# UNITED STATES PATENT AND TRADEMARK OFFICE

APPLICATION NO.	FILING DATE	FIRST NAMED INVENTOR	ATTORNEY DOCKET NO.	CONFIRMATION NO.
09/680,277	10/06/2000	Je Hong Kim	2658-0242P	8486

**Office Action Summary**

## **DETAILED ACTION**

**FIG. 1**

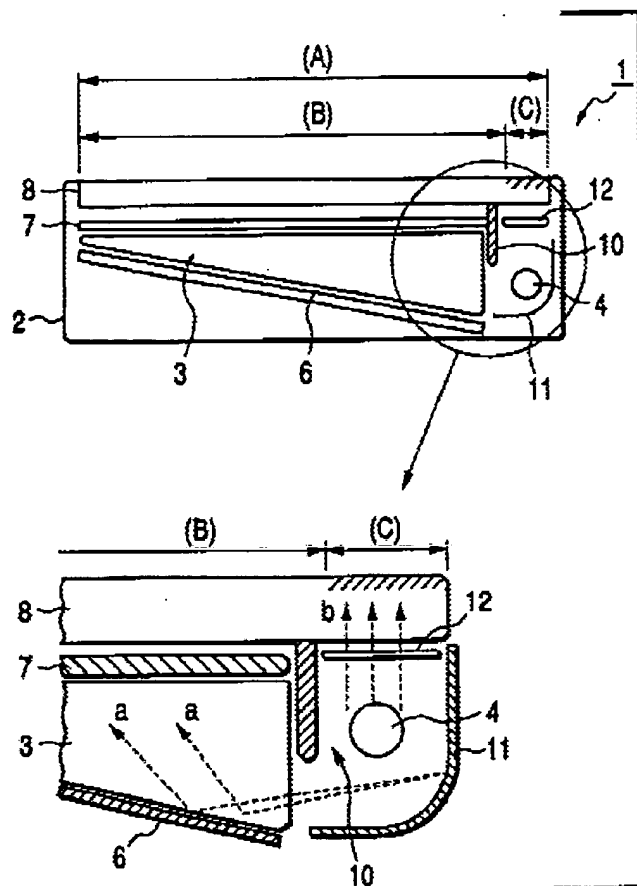
Matsushita teaches in the first embodiment, Figure 1, the use of a light input device wherein a light shielding plate, 10, is disposed so that part of the light emitted from the linear light source and reflected by the reflecting plate, 11, is condensed (Applicant's high focusing) at the end portion (col. 6, lines 22-29) of the light conduction plate, 3 (Applicant's light guide), in order to improve display visibility so the LCD can be formed as a vehicle-mounted alarm display device for displaying various alarms (Abstract). As can be seen in Figure 1, the light is substantially directed to a rear side of said light input device in a direction away from the light guide prior to directing said light path to a front side thereof and toward the light guide to obtain high focusing of the light beam.

Matsushita is evidence that ordinary workers in the art of liquid crystals would find the reason, suggestion, or motivation to add a light input device wherein a light shielding plate is disposed so that part of the light emitted from the linear light source and reflected by the reflecting plate is condensed (Applicant's high focusing) at the end portion of the light conduction plate in order to improve display visibility so the LCD can be formed as a vehicle-mounted alarm display device for displaying various alarms.

Therefore, it would have been obvious to one having ordinary skill in the art of liquid crystals at the time the invention was made to modify the LCD of APA by directing a light path of a light beam substantially to a rear side of said light input device in a direction away from the light guide prior to directing said light path to a front side thereof

FIG. 4

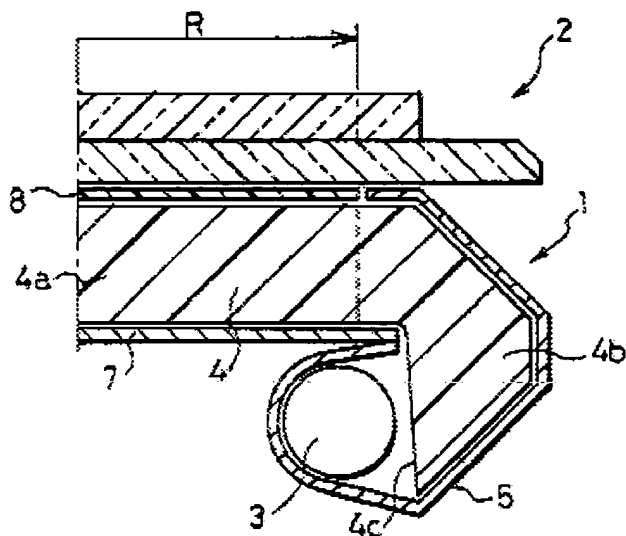
Oyama teaches in Figure 4 a light unit comprising a light-guide plate, 4a, and a reflector, 5, having a sectional view of spiral shape that efficiently guides the light

Oyama teaches in Figure 4 a light-guide plate, 4a, installed at height different from the light, 3, input to reduce the outside dimensions of the entire apparatus with respect to the area of the display space (col. 2, lines 53-60) having a sectional view of spiral shape, resulting in light passed through the light input device to be incident into the light-guide plate without being incident directly to the light-guide plate. Note this motivation (to reduce the outside dimensions of the entire apparatus) is applicable regardless of element 4b.

Oyama is evidence that ordinary workers in the art of liquid crystals would find the reason, suggestion, or motivation to add a light-guide plate installed at height different from the light input to reduce the outside dimensions of the entire apparatus with respect to the area of the display space, resulting in light passed through the light

Therefore, it would have been obvious to one having ordinary skill in the art of liquid crystals at the time the invention was made to modify the LCD of APA in view of Matsushita with the light-guide plate installed at height different from the light input device of Oyama, resulting in light passed through the light input device to be incident into the light-guide plate without being incident directly to the light-guide plate, to reduce the outside dimensions of the entire apparatus with respect to the area of the display space.

FIG.14(b)

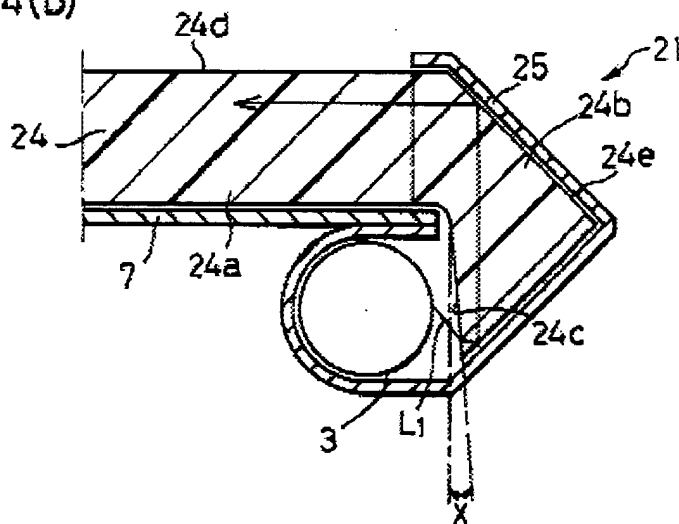
As to claim 5, Oyama teaches in Figure 14(b) a back light unit wherein the reflective plate, 25, is curved to obtain a desired vertical incident angle of the light beam progressing to the light-guide plate to reduce bright lines in the display near the light source (col. 13, lines 33-52, especially lines 42-48).

Oyama is evidence that ordinary workers in the art of liquid crystals would find the reason, suggestion, or motivation to use a light unit wherein the reflective plate is curved to obtain a desired vertical incident angle of the light beam progressing to the light-guide plate to provide desired illumination characteristics.

Therefore, it would have been obvious to one having ordinary skill in the art of liquid crystals at the time the invention was made to modify the LCD of APA in view of Matsushita with the curved reflective plate of Oyama.

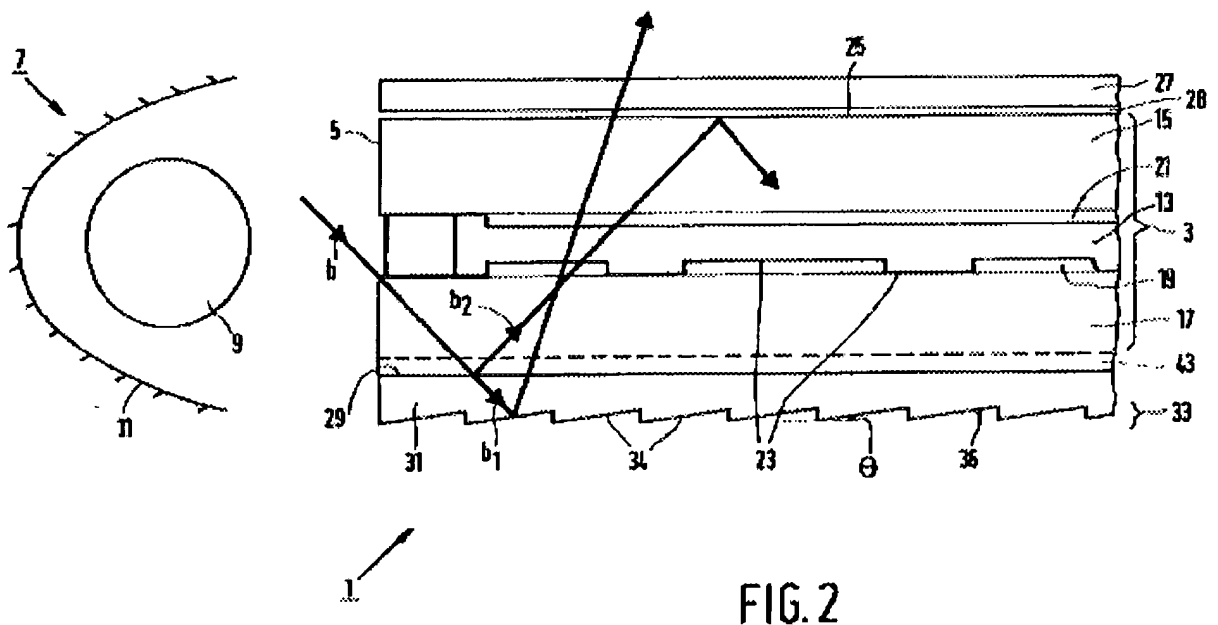
As to claim 7, Oyama teaches in Figure 14(a) a back light unit wherein the lamp housing includes at least one reflective plate for cutting off the light beam progressing directly from the lamp into the light-guide plate, the at least one reflective plate being a protrusion of the inner surface of the lamp housing.

Oyama is evidence that ordinary workers in the art of liquid crystals would find the reason, suggestion, or motivation to use a reflective plate for cutting off the light beam progressing directly from the lamp into the light-guide plate, the at least one reflective plate being a protrusion of the inner surface of the lamp housing to provide desired illumination characteristics.

Therefore, it would have been obvious to one having ordinary skill in the art of liquid crystals at the time the invention was made to modify the LCD of APA in view of Matsushita with the protruding reflective plate of Oyama.

**FIG. 7**

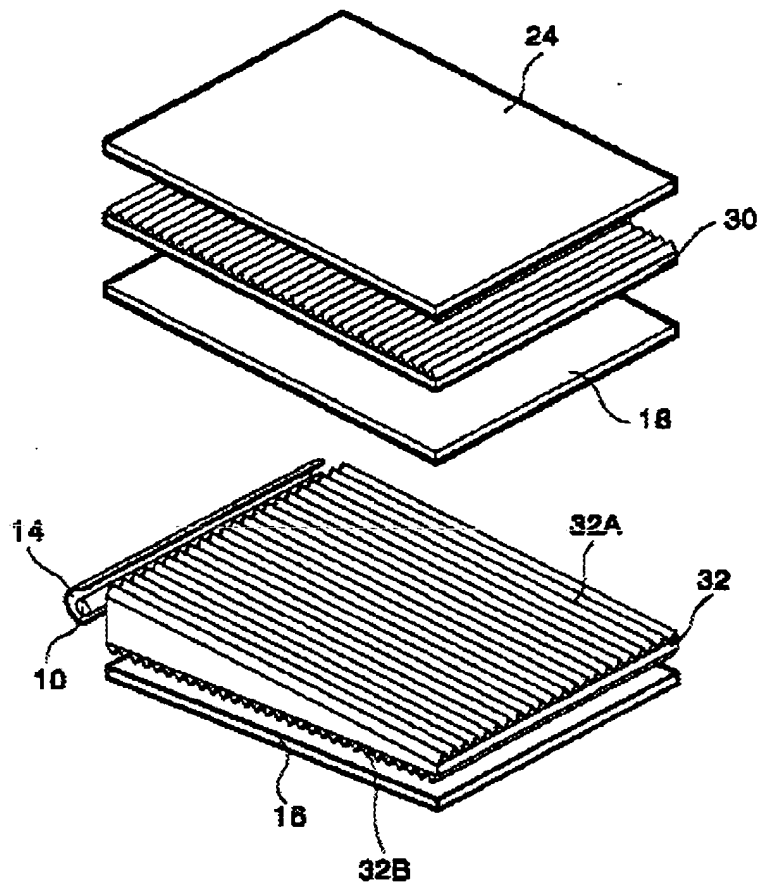
Kim teaches in Figure 7 the use of a light unit wherein the light-guide plate includes a plurality of prism patterns arranged on another surface thereof in intersection with the unit patterns.

Kim is evidence that ordinary workers in the art of liquid crystals would find the reason, suggestion, or motivation to add a plurality of prism patterns arranged on another surface thereof in intersection with the unit patterns to enhance the utilization ratio of the light generated by the lamp (col. 6, line 58 through col. 7, line 15).

Therefore, it would have been obvious to one having ordinary skill in the art of liquid crystals at the time the invention was made to modify the LCD of APA in view of Matsushita and Broer with the plurality of prism patterns arranged on another (upper) surface of the light guide plate of Kim.

FIG. 1

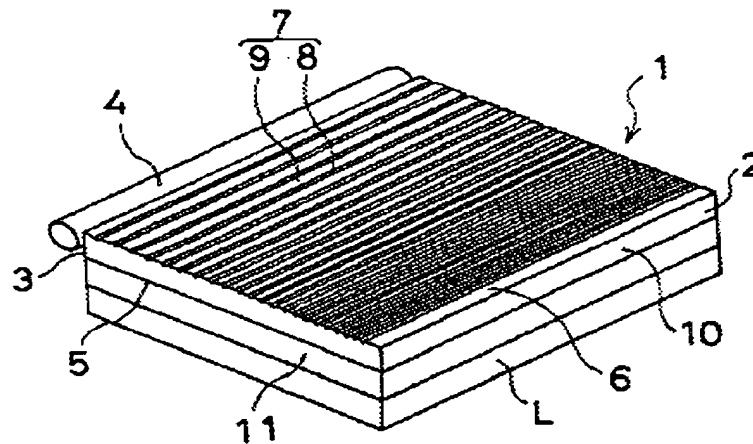
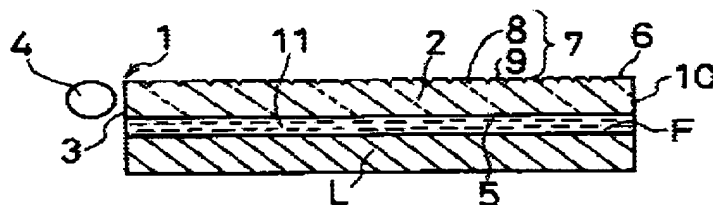
Egawa teaches in Figures 1 and 2 a light guide plate dispose on the front side of a liquid crystal panel to provide illumination without degrading contrast and without generating a moiré pattern (col. 4, lines 11-17).

Egawa is evidence that ordinary workers in the art of liquid crystals would find the reason, suggestion, or motivation to add a light guide plate disposed on the front side of a liquid crystal panel to provide illumination without degrading contrast and without generating a moiré pattern.

Therefore, it would have been obvious to one having ordinary skill in the art of liquid crystals at the time the invention was made to modify the LCD of APA in view of Matsushima and Broer with the light guide plate disposed on the front side of a liquid crystal panel of Egawa.

Egawa teaches in Figures 1 and 2 a light guide plate wherein a distance between the unit patterns that gets gradually shorter as said unit patterns get farther away from the incident side of the light-guide plate so that the brightness becomes nearly uniform at any position in the transparent substrate (light guide) without being influenced by the distances from the light source lamp (col. 12, lines 34-50).

Egawa is evidence that ordinary workers in the art of liquid crystals would find the reason, suggestion, or motivation to add a distance between unit patterns that gets gradually shorter as said unit patterns get farther away from the incident side of the light-guide plate so that the brightness becomes nearly uniform at any position in the light guide without being influenced by the distances from the light source lamp.
